Technical Journal

Hard to fill fuel due to frozen filler pipe

REF NO: TJ 34215.3.1	ISSUING DEPARTMENT: Technical Service	CAR MARKET: United States and Canada		
3 US 7	PARTNER: 7510 Volvo Car USA	ISSUE DATE: 2019-04-02	STATUS DATE: 2019-04-11	
FUNC GROUP: 2340	FUNC DESC: Fuel tank, fuel lines, evaporator system	Page	1 of 3

File Name	File Size
Fuel hatch.PNG	0.0780 MB

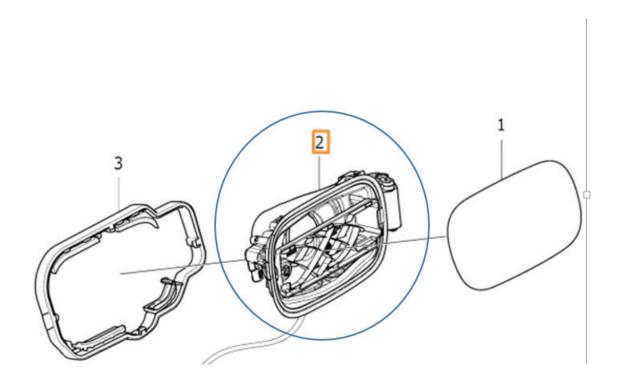
If customer complains about difficulties to refuel due to frozen filler pipe, please follow advise under "service".

*New fuel hatch for XC60, V60 and V60CC was released 2019w11.

Replace the fuel hatch according to VIDA. New fuel hatch was released 2018w40(90 cluster) with new sealing concept. See attachment.
